**STAFF REPORT**  
**COMMUNITY DEVELOPMENT DEPARTMENT**

SUBJECT: SHP-2021-0006  
McCrea Meadow Short Plat

LOCATION: The site is located at 1028 NE 3rd St. in the S ½ of the NW ¼ of Section 7, Township 3N, Range 1E.

The Applicant proposes a Short Plat to create two buildable lots on 0.3 acres of land in the R-15 zoning district.

### A. Proposed Short Plat (date: 2/1/22)

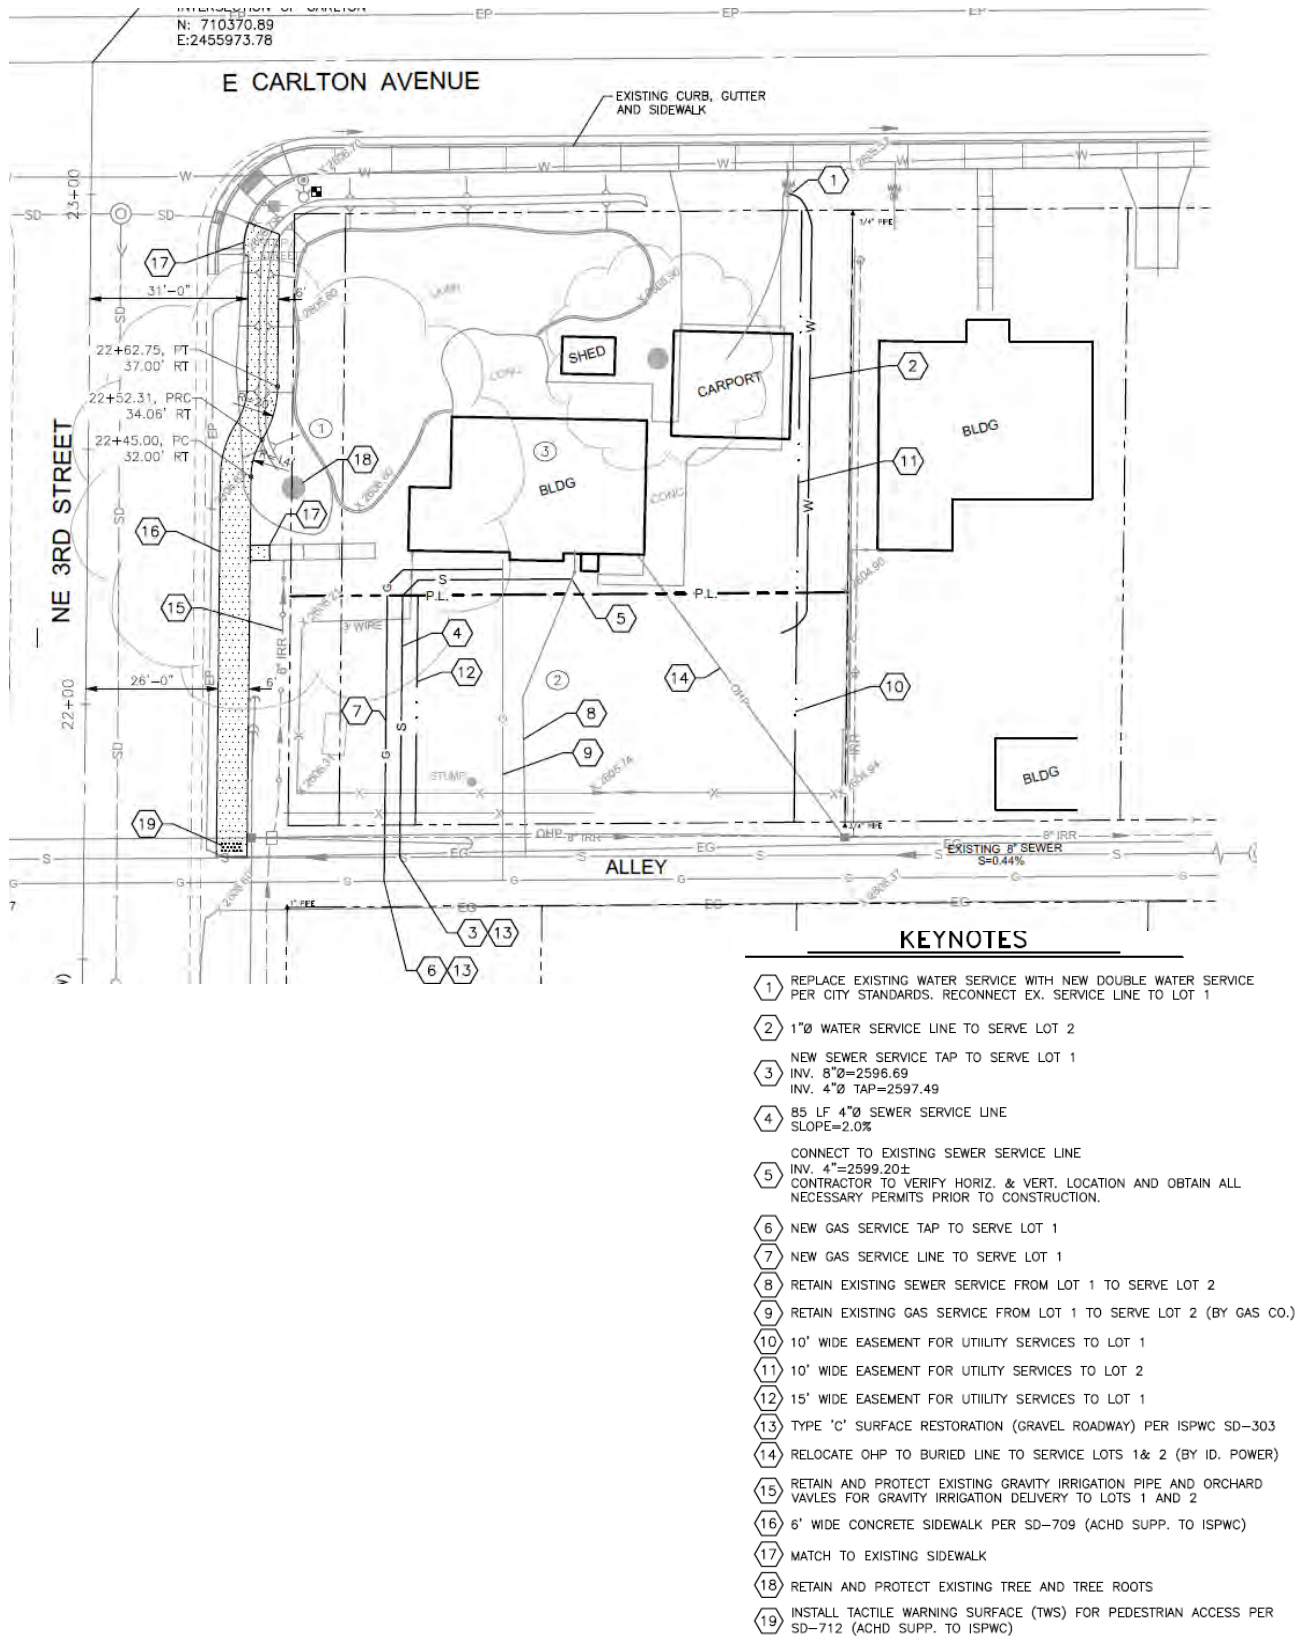
1. The short plat prepared by Kyle Koomler of Civil Survey Consultants, Inc included in Section VI.B shall be revised as follows:
  - a) A 20 ft. landscape easement as measured from the property line shall be indicated along the western property line. Landscape easement shall be vegetated in accord with UDC 11-3B-7 unless alternative compliance has been approved by the Director.

- b) A 10 ft. wide sewer easement connecting to E. Carlton Ave. shall be reflected within the landscape easement along the western property line.
2. All unimproved right-of-way along the property east of the proposed sidewalk, as well as the 20 ft. wide landscape easement shall be landscaped with lawn or other vegetative cover and maintained by the applicant or as otherwise indicated by a license agreement between the property owner and ACHD.
